# SEND\_SLEEP to SEND\_ALERT Problem

Brian Edem - Marvell Feb 14, 2020

## EEE transmit state diagram

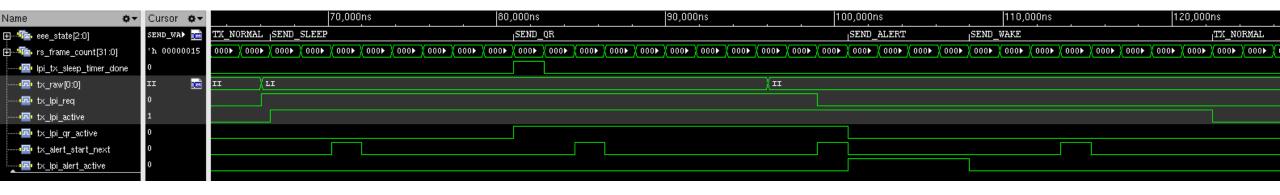
- SEND\_SLEEP is entered at any rs\_fec\_frame boundary
- Exit to SEND\_QR is taken for longterm LPI – "normal" progression
- Exit to SEND\_ALERT is taken for early exit from LPI
- Transition from SEND\_QR to SEND\_ALERT is aligned to tx\_alert\_start\_next via removal of tx\_lpi\_req

## Early exit from LPI (while in SEND\_SLEEP)

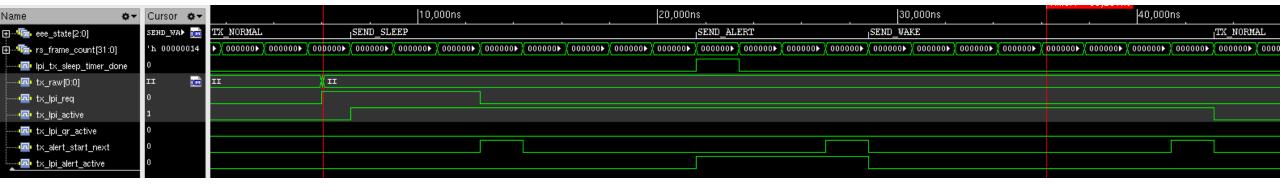
- Tx\_lpi\_req can become false at any point in SEND\_SLEEP
- Exit from SEND\_SLEEP is controlled by lpi\_tx\_sleep\_timer\_done, which is not aligned to the ALERT window
- This allows the transition to SEND\_ALERT and the transmission of ALERT to have an arbitrary alignment to the ALERT window
- Note that tx\_alert\_start\_next occurs during tx\_lpi\_alert\_active

## Solution

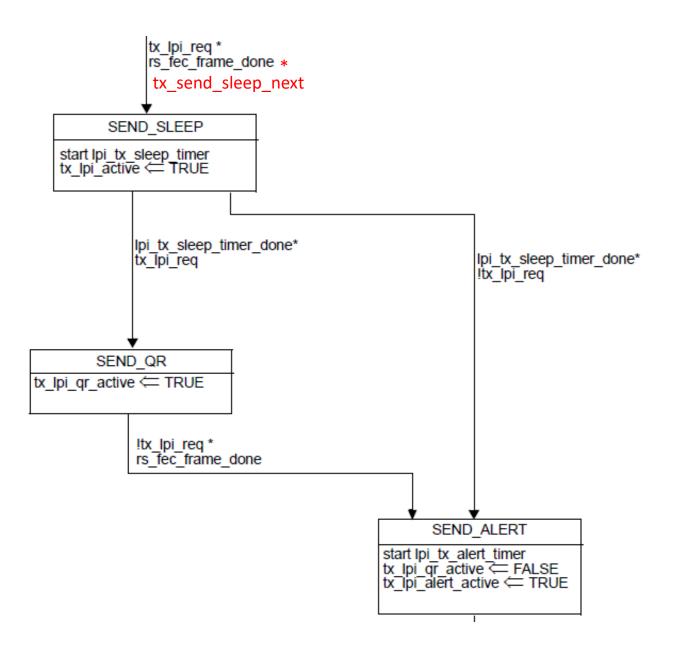
- One solution is to align the entry to SEND\_SLEEP to the ALERT window
- This ensures that the exit of SEND\_SLEEP 8 RS-FEC frames later will also be aligned to the ALERT window
- tx\_alert\_start\_next could be used to align entry to SEND\_SLEEP but will delay entry to SEND\_SLEEP in slowwake mode
- Introduce tx\_send\_sleep\_next variable for alignment
- tx\_send\_sleep\_next has same timing as tx\_send\_alert\_next in fast-wake mode

## Alternate Solutions

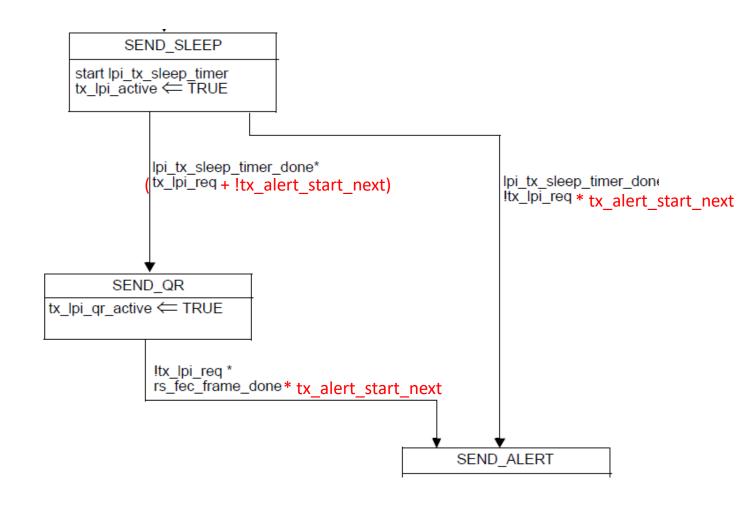
- Force SEND\_SLEEP to SEND\_QR with if !tx\_alert\_start\_next
  - SEND\_QR will immediately transitions to SEND\_ALERT
  - Would need to further qualify transition to SEND\_ALERT with tx\_alert\_start\_next
